BULLETIN CT-01

Date: September 1st, 2022	Number: CT-1	Project #: 21162
Project Name: Piper Remodel	Attached: REV2 structural drawings (Delta 2 – Bulletin CT-1)	
Number of Pages: 17

Subject: Grade beam revisions
Main Floor framing revisions
Main Floor sheathing addition (thickness and nailing)

Drawings affected: S2.0, S2.1

ONE ~ COLUMN ~ 3A
 NORTH COLUMN

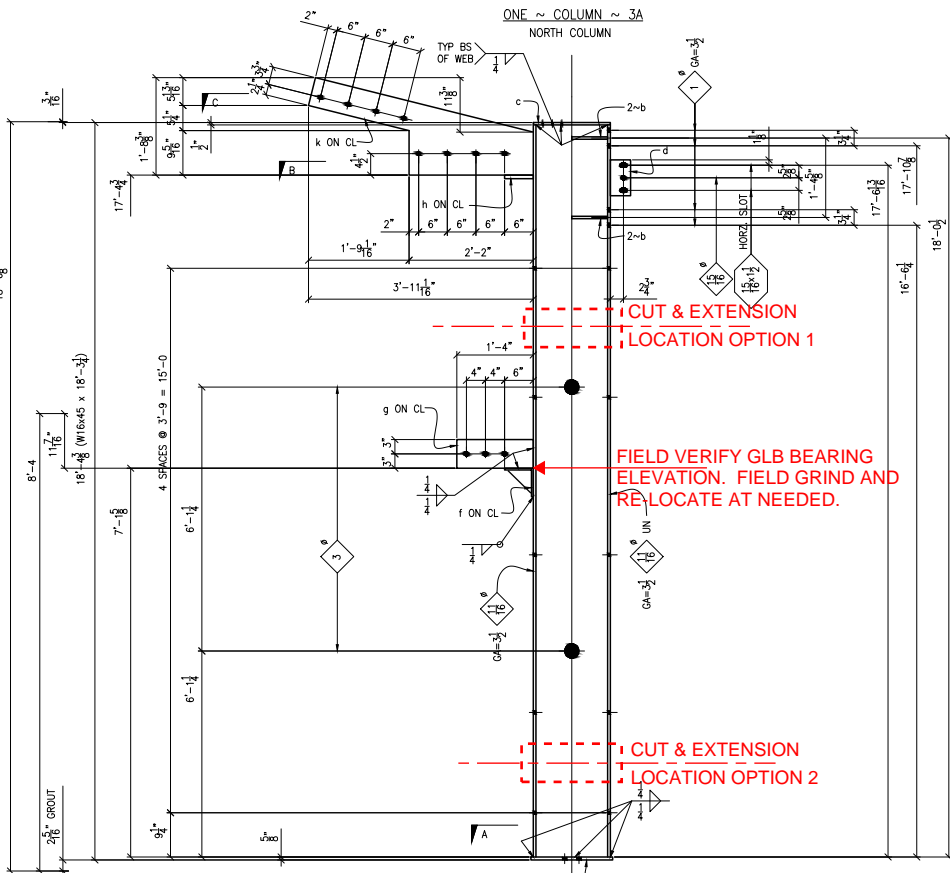
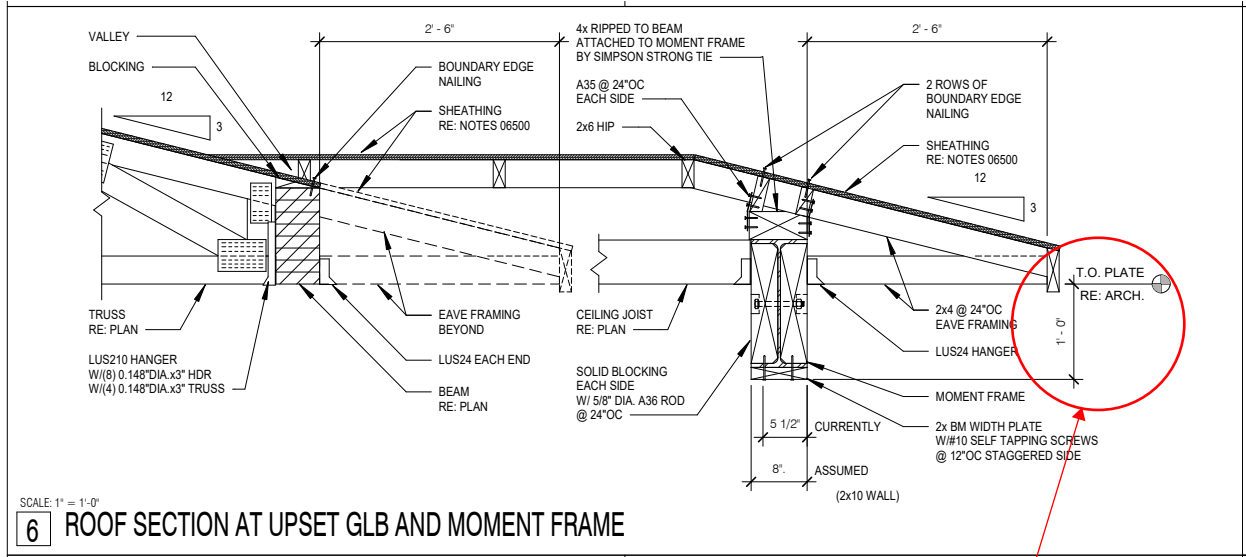
IF GLB BEARING WAS LOCATED AT THE CORRECT ELEVATION, THEN CUT AND EXTEND FRAME AT LOCATION OPTION 1. IF GLB BEARING ELEVATION REQUIRES RE-LOCATION, THEN CUT AND EXTEND FRAME AT LOCATION OPTION 2. BOTH OPTION ARE LOCATED AT THE MID POINT BETWEEN THE HOLES IN THE FLANGES. PLEASE SEE REPAIR **DETAIL A** FOR FRAME COLUMN LEG EXTENSION WELDING REQUIREMENTS. CONTRACTOR TO PROVIDE FIELD EXTENSION DIMENSION FOR EACH COLUMN SUCH THAT THE OVERALL FRAME ELEVATION MEETS THE REQUIREMENTS SHOWN IN DETAIL 6/S9.1. PLEASE SEE DETAIL WITH MARKED UP DIMENSION NEXT SHEET.

OVERALL FRAME ELEVATION SHALL BE SUCH THAT THE DISTANCE FROM THE TOP PLATE TO THE BOTTOM OF THE 2X ATTACHED AT THE BOTTOM FLANGE OF THE BEAM SHALL BE 1'-0"

A | MOMENT FRAME COLUMN EXTENSION

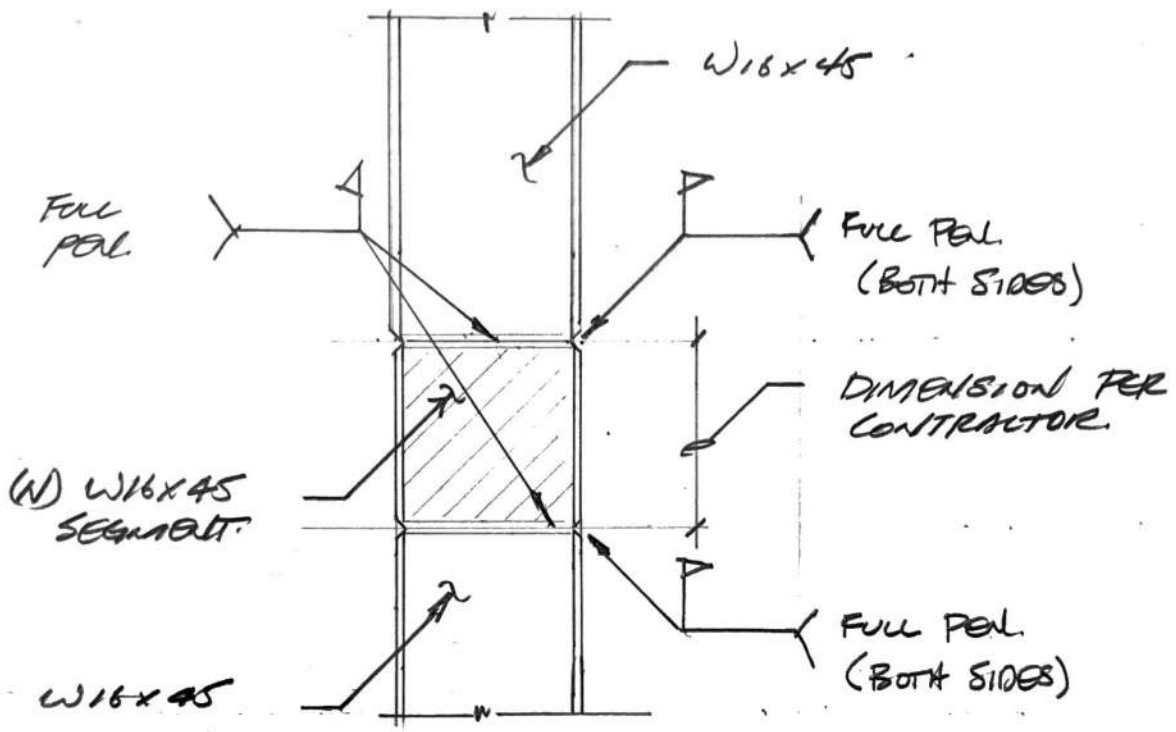
SPECIAL INSPECTION REQUIRED (NON-DSTRUCTIVE TESTING OF WELDED JOINTS)
 UT SHALL BE PERFORMED ON 20% OF CJP GROOVE WELDS.

It is structurally acceptable to modify the moment frame column legs per detail sketch A attached. The contractor will need to provide the dimension that the frame legs need to be extended. Additionally, we have provided two optional elevation locations to extend the frame legs, depending on the as-built location of the GLB bearing bracket. We have allowed for the welding to be done in the field. The welds will need to be special inspected in the field.

Ultrasonic testing (UT) is required on 10% of complete joint penetration (CJP) welds that are over 5/16" thick per the requirements of AISC 360, therefore one of the four flanges welded with CJP shall be UT tested. The web is not required to be UT tested.

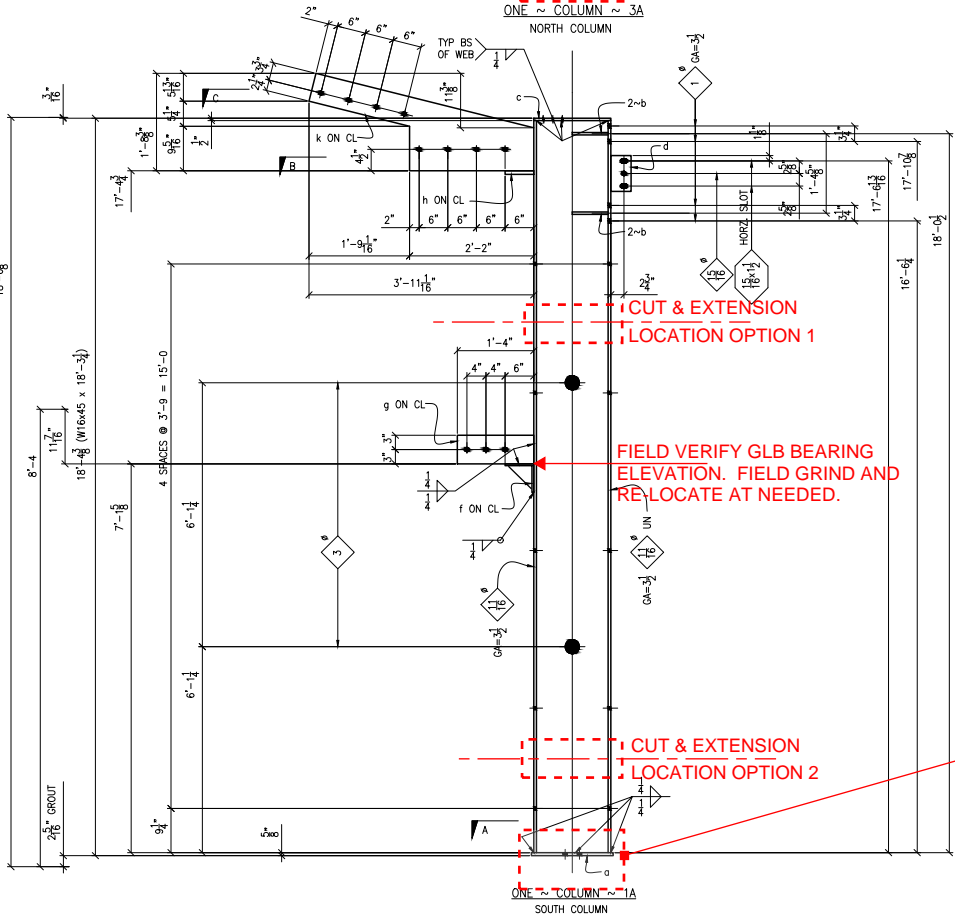
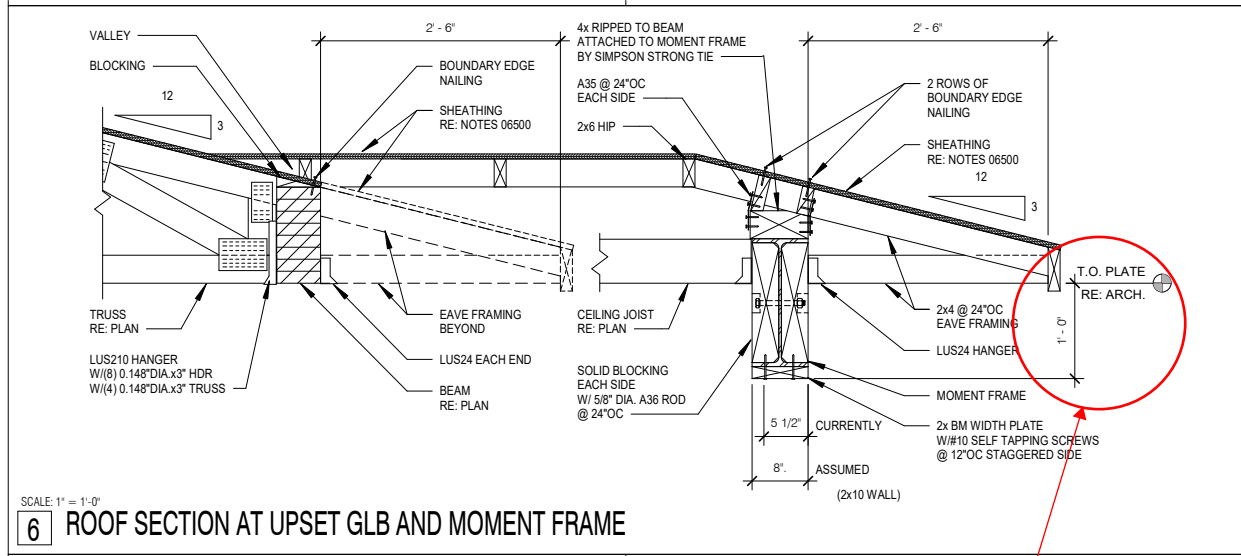
11/15/2022
SEE A ALTERNATE TO
EXTEND FRAME AT THE
BASE

IF GLB BEARING WAS LOCATED AT THE CORRECT ELEVATION, THEN CUT AND EXTEND FRAME AT LOCATION OPTION 1. IF GLB BEARING ELEVATION REQUIRES RE-LOCATION, THEN CUT AND EXTEND FRAME AT LOCATION OPTION 2. BOTH OPTION ARE LOCATED AT THE MID POINT BETWEEN THE HOLES IN THE FLANGES. PLEASE SEE REPAIR **DETAIL A** FOR FRAME COLUMN LEG EXTENSION WELDING REQUIREMENTS. CONTRACTOR TO PROVIDE FIELD EXTENSION DIMENSION FOR EACH COLUMN SUCH THAT THE OVERALL FRAME ELEVATION MEETS THE REQUIREMENTS SHOWN IN DETAIL 6/S9.1. PLEASE SEE DETAIL WITH MARKED UP DIMENSION NEXT SHEET.

11/15/2022
SEE A ALTERNATE TO
EXTEND FRAME AT THE
BASE

W16X45 MOMENT FRAME - BASE EXTENSION

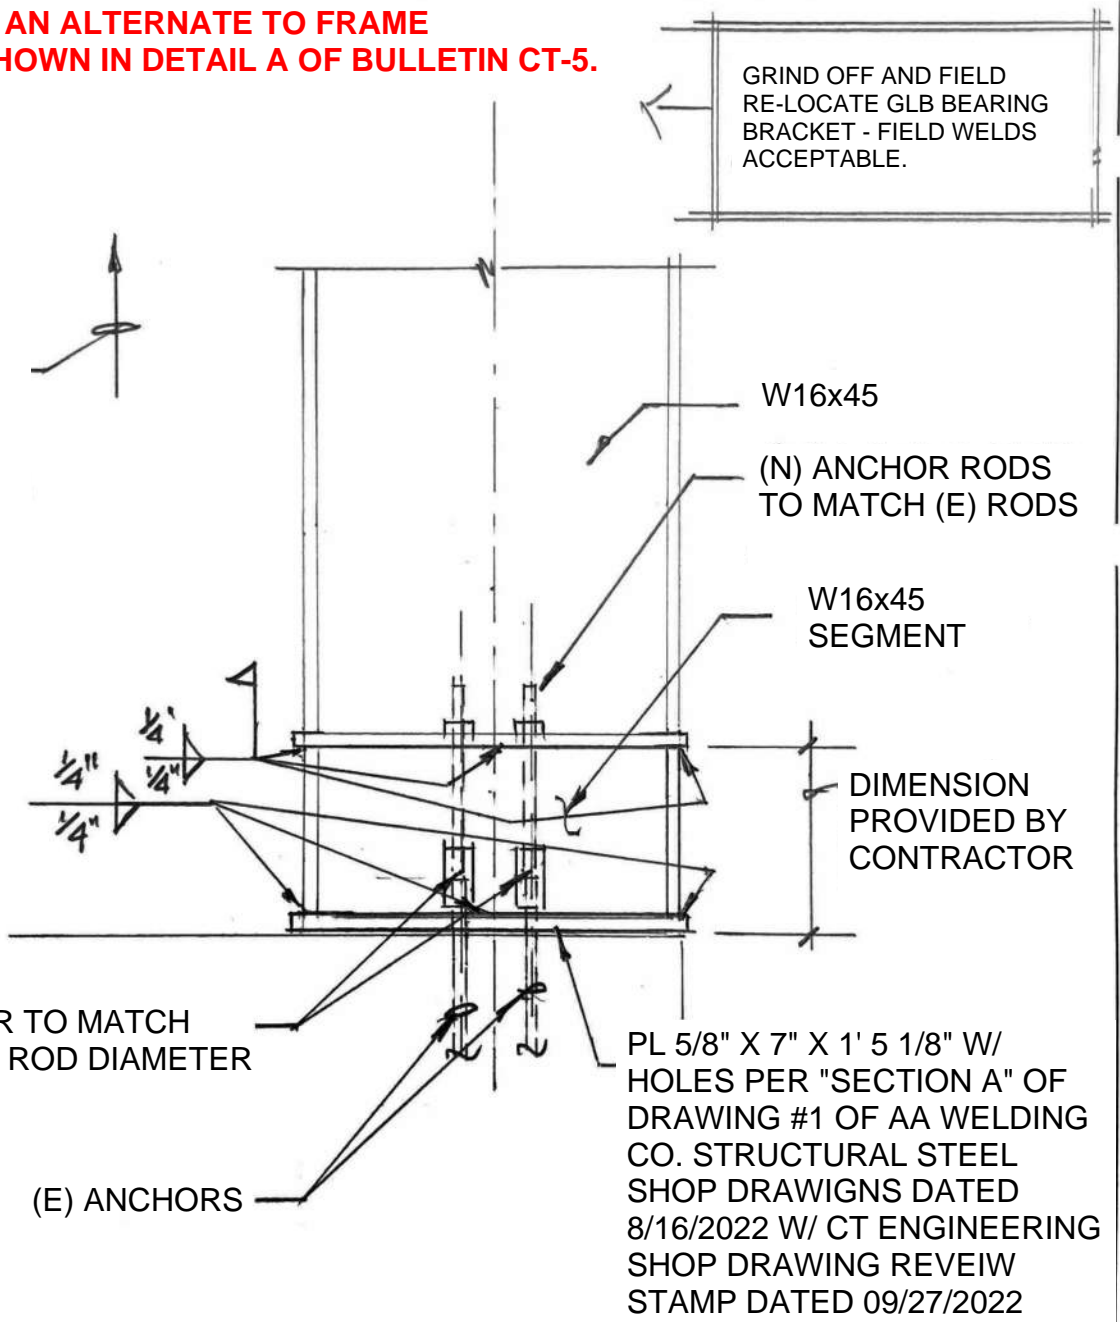
**PROVIDED AS AN ALTERNATE TO FRAME
EXTENSION SHOWN IN DETAIL A OF BULLETIN CT-5.**

GRIND OFF AND FIELD
RE-LOCATE GLB BEARING
BRACKET - FIELD WELDS
ACCEPTABLE.

PL 5/8" X 7" X 1' 5 1/8" W/
HOLES PER "SECTION A" OF
DRAWING #1 OF AA WELDING
CO. STRUCTURAL STEEL
SHOP DRAWINGS DATED
8/16/2022 W/ CT ENGINEERING
SHOP DRAWING REVIEW
STAMP DATED 09/27/2022

Roof Framing Over Main Level Shear Walls

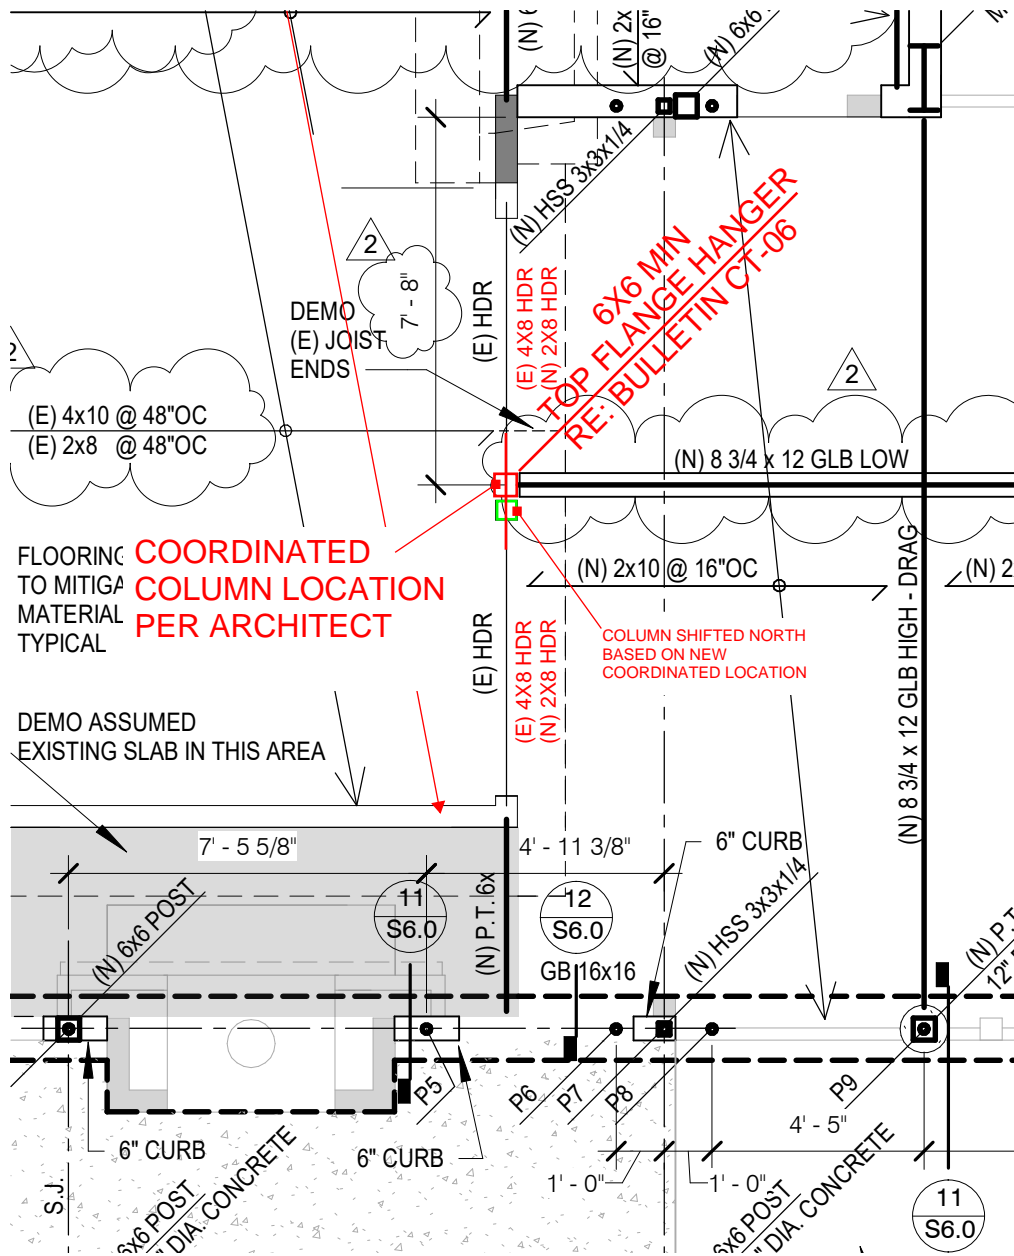
SHIFT HIP AND VALLEYS AS SHOWN IN RED, PROVIDING NORTH END EVE EXTENSION TO HOUSE MOMENT FRAME BELOW ROOF PLYWOOD LEVEL.

ACCEPTABLE TO LOCALLY REMOVE WOOD TOP PLATE AS NEEDED TO CLEAR PLYWOOD. FRAME EXPECTED TO ENTIRELY CLEAR THROUGH.

2-2X4 X (8'-0") STRUCTURAL FACIA TO SUPPORT HIP END - DISCONTINUOUS AT FRAME

Additionally, please see revised roof plan with extended eave at the north end of the stairs as well as slight hip and valley angle revisions to accommodate housing the north side moment frame leg below the roof line.
